Project: CFS-3

Subject: Devens Peer Review Letter

Please kindly review the responses to the comment letter received 23 December, 2025 with regard to the submittal for CFS-3 125 Hospital Road – Level 2 Unified Permit Application documents dated 11 December 2025.

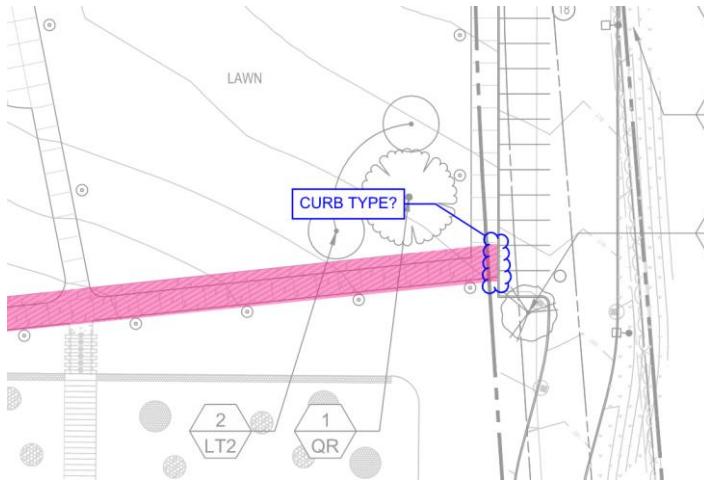
- a. The true extent of the R&D for the site landscape is not documented. Please provide additional notes, or graphic representation of the R&D. Include these trees and the tree protection symbol on all plans with the true canopy size and update the tree protection detail to extend a minimum of 12" beyond the dripline of trees. Provide a description of the excavation methods within rootzones of trees to remain.

- b. The tree protection lines are not accurate as shown on the plans, as certain construction activities cannot be accomplished without cutting through dripline/root zones of existing trees if show at true size in plan. Adjust the limit of tree protection line and identify means of tree protection to remain in place for the duration of the project on all plans.

- c. Existing tree sizes are not shown on the plans; identify all trees over 12" within 100' of the property line and indicate the true canopy size of all trees to remain, or as otherwise directed by DEC representative. Our understanding is the DEC has granted a waiver for the 100' dimension but requests all trees with driplines affected by the Limit of Work shall be documented on all plans. This shall include those inside and outside the Limit of Work.

- d. Provide a Limit of Work on all plans that accurately reflects the maximum limit of disturbance during construction that does not extend to within 12" of the dripline of any trees to be protected for the entire duration of the construction activities, including those within the right of way to be protected.

Comments noted. Please be advised that in its initial permit submission applicant requested a waiver from the requirement to locate and show existing specimen trees within 100' of exterior parcel boundary lines for reasons articulated in the application. Applicant is presently working directly with DEC staff on a strategy to identify impacted trees in close proximity to the grading limits of disturbance in the field prior to clearing, which might benefit from small slope grading adjustments.

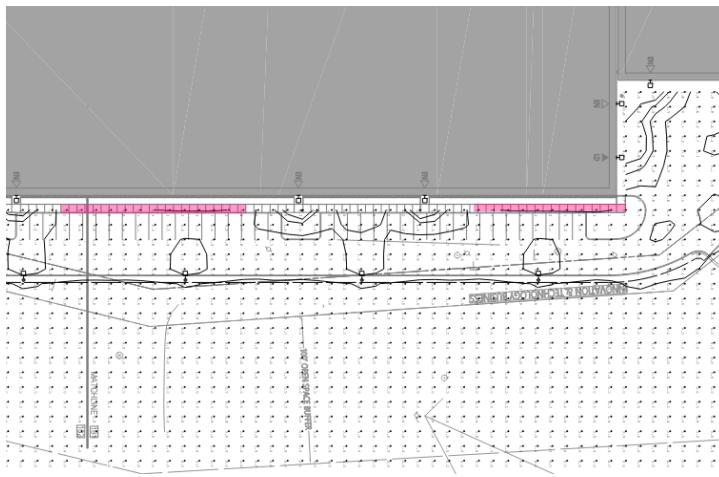
- b) Proposed and existing trees to remain shall be included on site lighting plans and photometrics to ensure no conflicts.

Comment is not addressed. The symbols are added, but do not factor into the lighting levels/contours. The photometric plans are the same as before the trees were added.

Concur, proposed and existing vegetation will be added to the plans.

It is not a DEC requirement nor an industry standard to model the influence of trees in lighting calculations unless their effects would significantly impact the distribution (e.g. a continuous hedge row). Due to the varying impact of the courtyard trees, both seasonally and annually, combined with the column light locations and lack of disruption along any egress path, there is no compelling reason to include vegetation in the lighting calculations for this site.

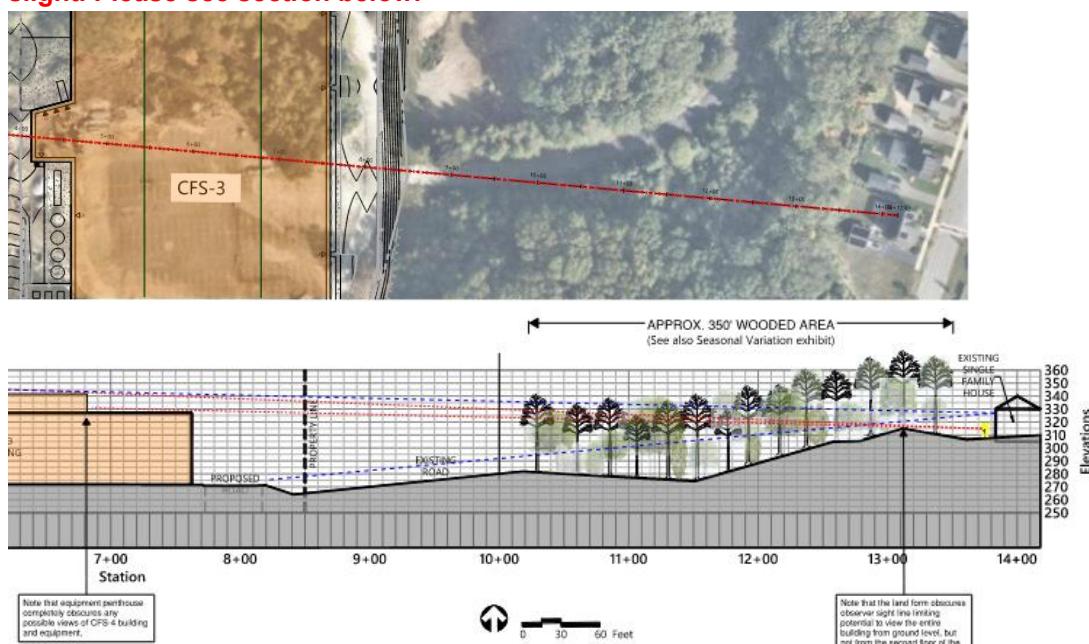
- c) On Sheets ES111 and ES112, foot candles far under 0.5 are shown on walkways along East side of the proposed building. Provide lighting to ensure safely lit walkways along this façade. Areas highlighted in pink (plan rotated, North is page right):

Suggest this could be better achieved with low level pedestrian-scale bollards, also with motion / daylight sensors to avoid additional glare and light pollution of wall packs on the building.

We recommend that these additional wall packs be on occupancy sensors to minimize façade illumination. These will be indicated on the plans, complementary to item (a) above.

Suggestion noted. The wall mounted fixtures were added to provide acceptable illumination along the walkways per the initial comment. These fixtures were selected due to the limited space available between the parking spaces and building facade.

Additionally, they will provide a consistent lighting strategy that matches the lights above the egress doors. With regard to glare and light pollution, the proposed wall packs will be on occupancy sensors to minimize façade illumination. Additionally, the mounting height of the fixtures is low, at 10' above grade. Further, Applicant's visibility assessment illustrates how the existing topography will obscure the view from the existing residences towards CFS-3. CFS-3 lies substantially lower, so the impact from the fixtures will be slight. Please see section below.

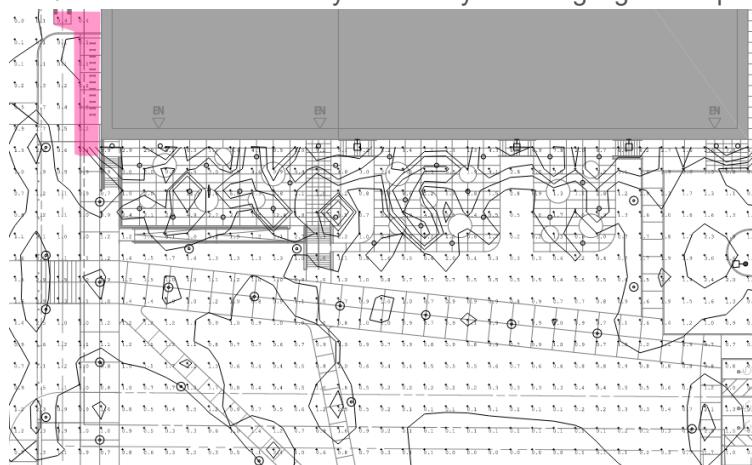
b) Proposed and existing trees to remain shall be included on site lighting plans and photometrics to ensure no conflicts.

Comment is not addressed. The symbols are added, but do not factor into the lighting levels/contours. The photometric plans are the same as before the trees were added.

Concur, proposed and existing vegetation will be added to the plans.

It is not a DEC requirement nor an industry standard to model the influence of trees in lighting calculations unless their effects would significantly impact the distribution (i.e. a continuous hedge row). Due to the varying impact of the courtyard trees, both seasonally and annually, combined with the column light locations and lack of disruption along any egress path, there is no compelling reason to include vegetation in the lighting calculations for this site.

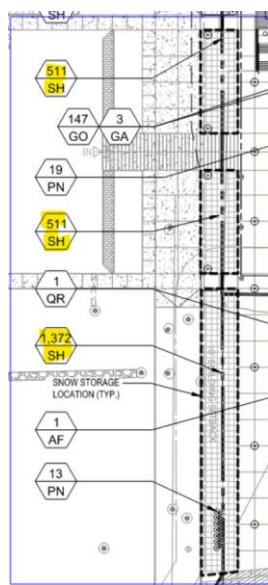
a) The following plant material is identified as having low tolerance to road de-icing salts and has been placed within 20' of proposed roads/paved areas and should be substituted with tolerant plants and/or moved out of 20' buffer:

Sporobolus monoculture remains and is specifically called out as snow storage areas which concentrates the de-icing chemicals. Revise and resubmit for review.

The identified plant material will either be substituted for salt tolerant material or shifted beyond the 20' offset from roadways.

Sporobolus heterolepis was selected to coordinate with CFS-1 planting design by Lemonbrooke, the landscape architecture firm tasked to set the landscape planting, lighting, and site furnishings palettes for the entire CFS campus. It provides interest year-round, tolerates a variety of soil conditions, and while some sources list it as a good roadside plant species (University of Maryland), we will substitute this for another species.

Sporobolus heterolepis will be replaced with two grass types: *Pennisetum alopecuroides* 'Hameln' (Dwarf Fountain Grass) and *Muhlenbergia capillaris* (Pink Muhly Grass), both of which are rated high for salt tolerance.

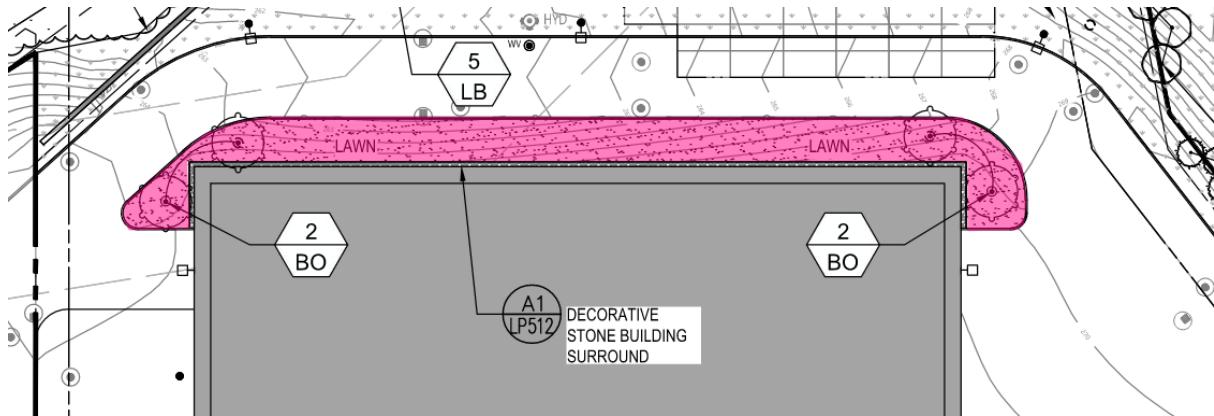
- a) Confirm that soil testing has been conducted and plant material has been selected based on the soil test results, specifically the New England Wetland Plants Wildflower Mix.

Topsoil test reports for the CFS site for the CFS-2 project have been provided to the CFS-3 design team. Soil tests were performed by UMass Amherst and dated May 2, 2025. The reports indicate test results along with recommendations for amendments. I reviewed the test results with New England Wetland Plants, and they indicated that the pH and organic matter content are acceptable. Further, NEWP indicated that too many additional inputs or amendments could potentially harm or burn the seed.

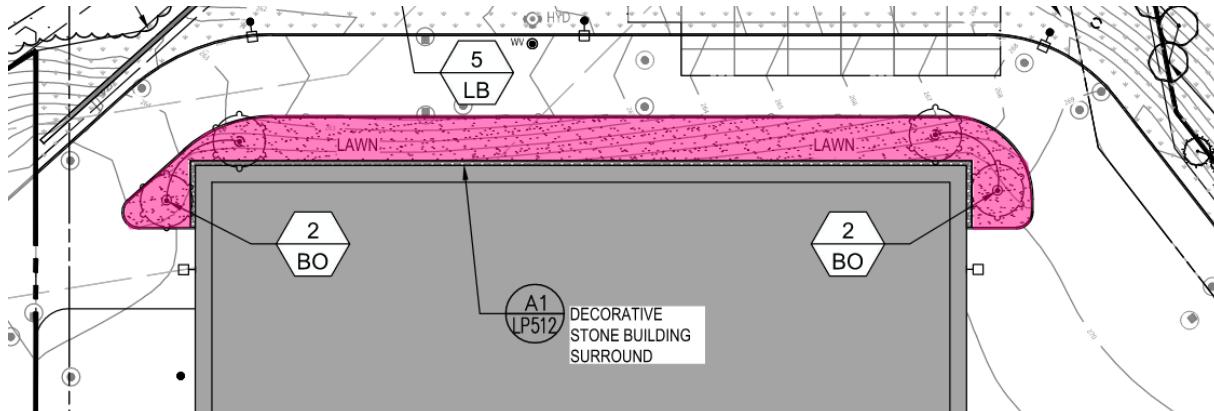
b) Confirm that 50:50 New England Wetland Plants Wildflower Mix and Erosion Control Mix for dry sites proposed at all areas to be re-graded is appropriate for 1:2.5 slopes. Consider a 100% Erosion Control Mix on steep slopes at or over 1:3, and Meadow Mix in areas under 1:3.

We agree with 100% Erosion Control Mix on steep slopes at or over 1:3, and 100% Meadow Mix in areas under 1:30

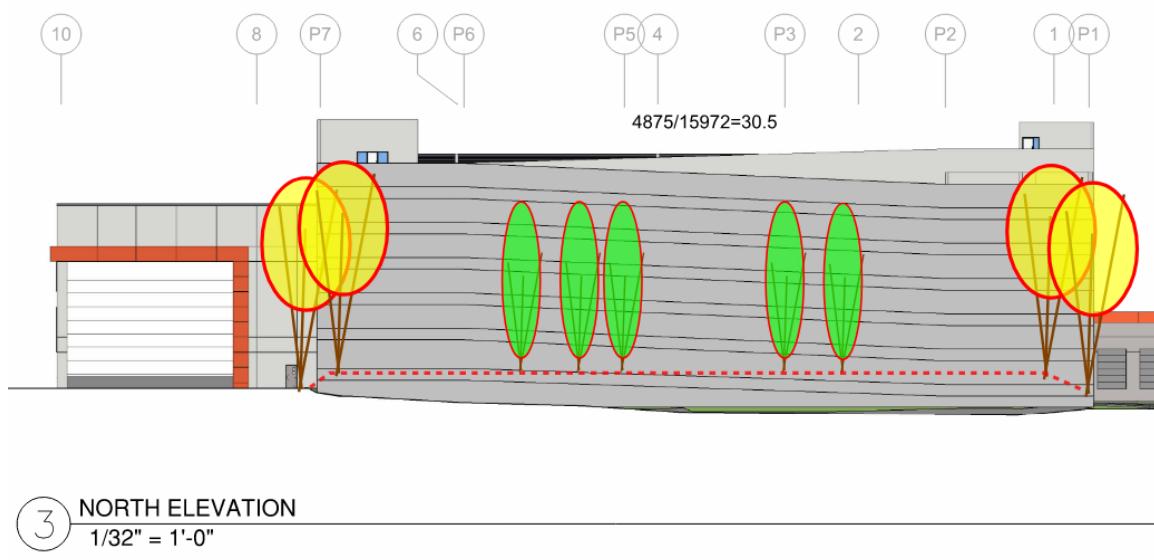
a) The North and East facades of CFS-3 will be visible from the Open Space/Recreation Zoning District. Additional screening plantings are needed along the North façade; proposed lawn and birches on building corners will not provide sufficient screening. Provide a dense mix of evergreen and deciduous trees along this façade to ensure year-round screening.

The *Betula* species selected seems too large for the location, likely growing into the garage and overhanging the truck route. The proposed evergreens are either underrepresented in plan scale, or too small to be effective as a screen. Suggest the applicant add the proposed buildings screening materials to the sheet PL-1 – PL-3 to effectively convey the screening solutions.

Per comment #6, and per item (5a), the highlighted area will be planted with deciduous and evergreen trees to help screen the garage. The understory layer will be planted with groundcover and native shrubs to stabilize the slope.

- **Betula papyrifera 'Renaissance'** was selected due to its moderate salt tolerance, narrower canopy (maxing out at 30' width), and relatively tall overall height, which would have the best impact on breaking down the scale of the garage. After evaluating several other species, this choice is the most preferable. The client will employ a pruning program for all trees to maintain shape and health.
- **Juniperus virginiana 'Mondell'** – will substitute with a mix of straight *Juniperus virginiana* and *Thuja occidentalis* 'Smaragd' Emerald Green Arborvitae.

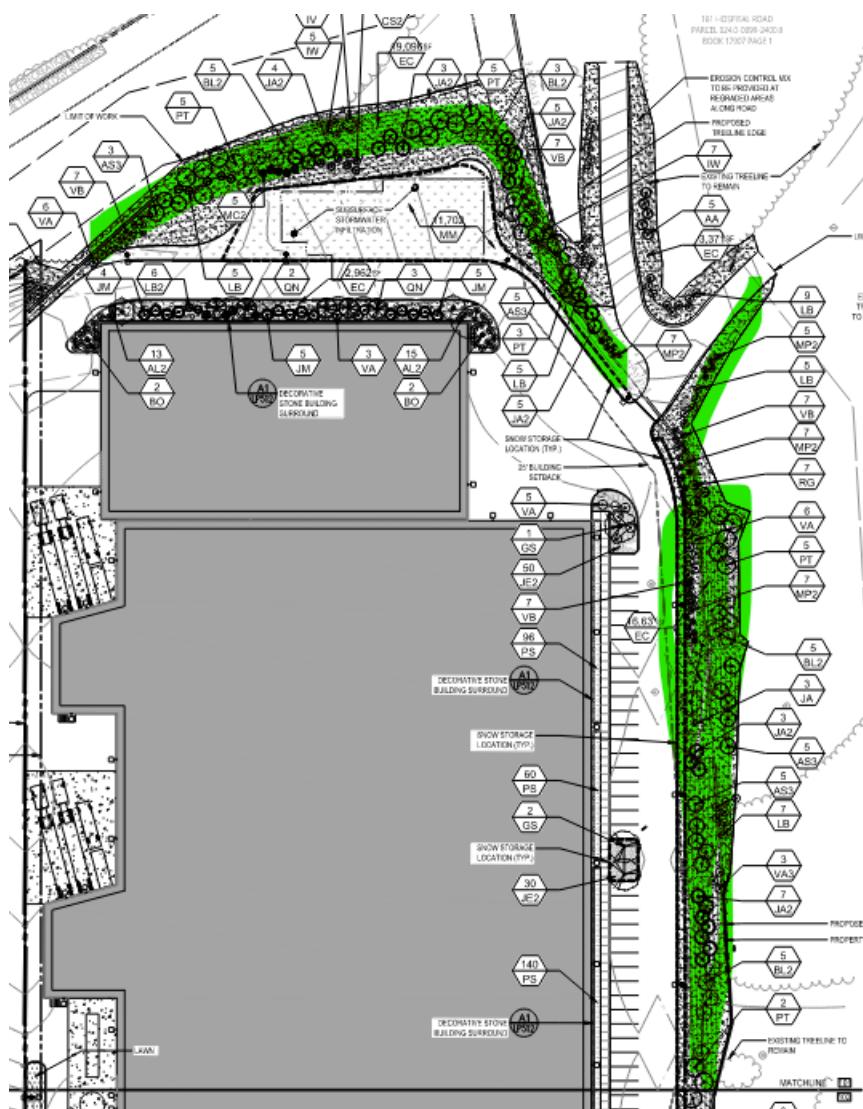
There seems to be an opportunity to increase the density of large evergreen planting on the north and east sides of the parking garage outside the vehicular circulation zones. As submitted, there is only one genus of evergreen in the plant schedule, *Juniperus*, both of which are varietals/cultivars. Our understanding is the DEC encourages planting of straight species to allow for the best chance of survival. Consider this for other plant selections as well. Indicating the trees in plan at 70-80% mature spread would also help to reinforce that the screening approach will be effective. Show mature height and spread in the plant schedule for all selections.

The need for additional screening in this area is reinforced by the proposed lighting levels within the garage. Though lower than the first iteration, the lighting levels within the garage still far exceed those required by DEC. Even if the levels are reduced further, it will be important to screen the light pollution from surrounding residential areas.

Suggestion noted. The Applicant and Architect are working directly with the DEC to improve architectural screening which will have the most beneficial impact from a visual standpoint.

We have reviewed the planting in the noted zones to increase the diversity of evergreen tree species. We will be providing a mix of Pine, Fir, and Holly alongside *J. virginiana*.

These areas along the wooded edge are being planted with whips. We did not provide full size symbols, as we felt it would be misleading in terms of what is being provided initially. These will grow into full size trees and provide a substantial buffer at the existing woodland edge.

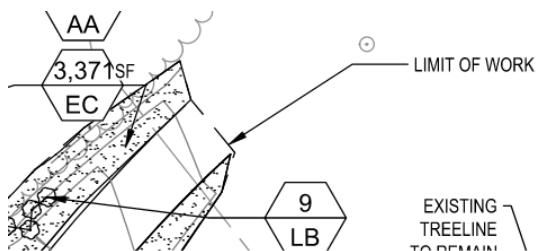
- c) Please label limit of work line, setback lines, property lines on all plans.

Non-concur; Limit Of Work is not provided on the landscape plans.

Limit of work has been indicated on landscape plans; additional callouts will be provided for clarity.

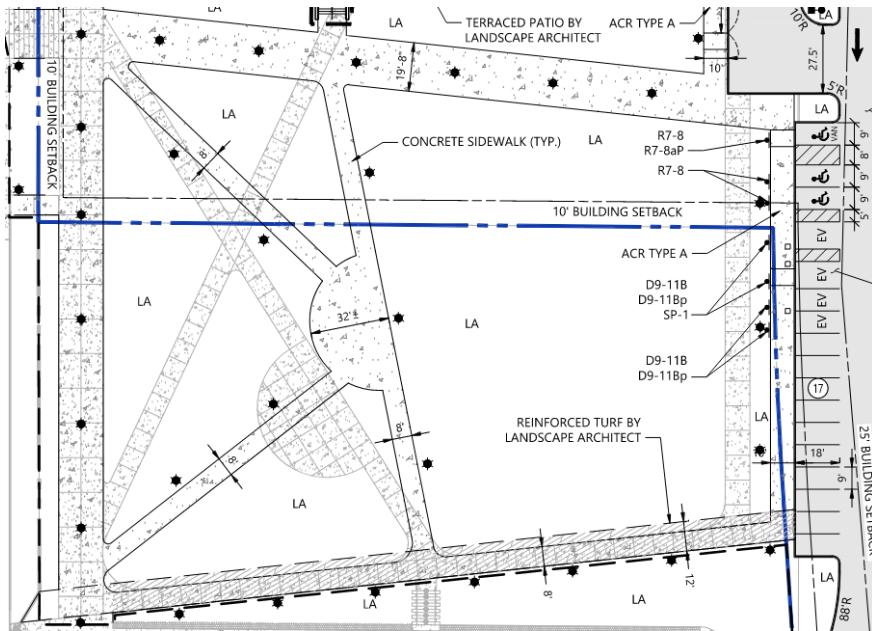
d) Some plans currently show proposed quad walkways and screened back walkways, but it is unclear which is correct. Please differentiate/label the two walkway layouts shown.

The screened back sidewalk in the campus green was part of a previously permitted design and was included to illustrate the changes proposed by this project. However, we understand that this has caused confusion and will remove the unnecessary linework from the plans.

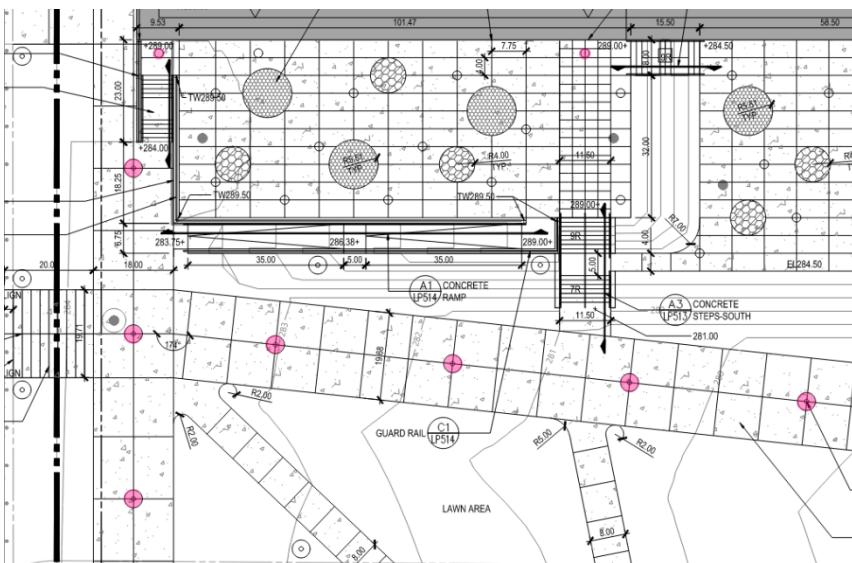
e) At terrace and quad south of proposed building, light poles are proposed in the middle of walkways. This layout is not feasible from a maintenance perspective, especially snow plowing. Consider shifting light poles off walkways and off center of path of travel for consistency and ease of maintenance.

The centered lights within the pavement are part of a concept previously approved by CFS to create promenades connecting the campus buildings. These paths are 20 feet wide which offer ample space for snow maintenance on either side of the poles. The concrete bases extend above the paved surface and will help to protect the poles from damage.

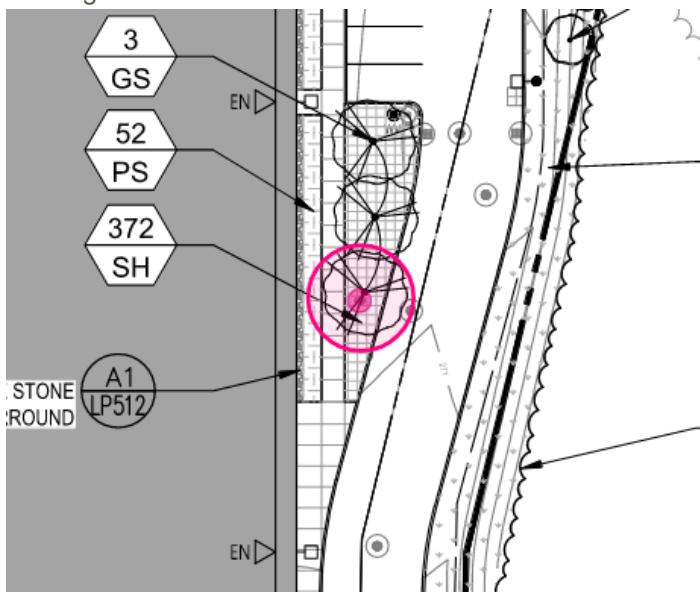
f) There is a potential conflict between 1 Ginko and a manhole at planted island on East side of building.

Concur, the tree will be adjusted or removed to eliminate the conflict.
